6906

3/4" IMPACT WRENCH

SERVICE CHANGES

1. Changes on Washer

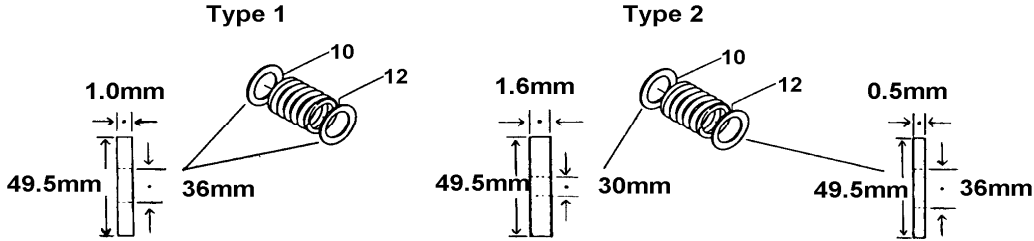
Item No.	Description	Type 1	Type 2
10	Flat Washer	253182-9	253764-7
12	Flat Washer	253182-9	253765-5
	Serial No.	~ 6809E	6810E ~

Above parts are completely interchangeable as a set.

2. Changes on Internal Gear

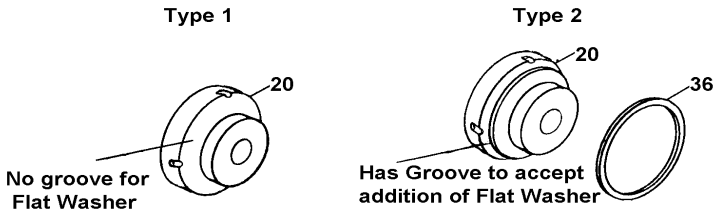
Item No.	Description	Type 1	Type 2
20	Internal Gear	221242-5 (N/A)	221242-5A
36	Flat Washer 65	-----	253774-4

Above parts are completely interchangeable as a set.

3. Changes on Anvil

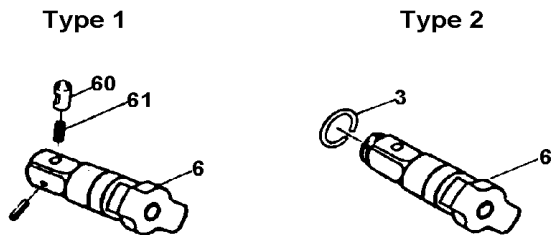
Item No.	Description	Type 1	Type 2	Type 3
3	Ring Spring 16	-----	231920-9A	231920-9A (component of item no. 6)
6	Anvil / Anvil Assy	325317-3	325586-6	134946-9 (Inc.item no.3)
60	Pin 7	231157-8 (N/L/A)	-----	-----
61	Compression Spring	256710-9	-----	-----
62	Pin 2	256710-9 (N/L/A)	-----	-----
	Serial No.	~ 10254E	~ 10255E - 151572E	151573E ~

Above parts are completely interchangeable as a set.
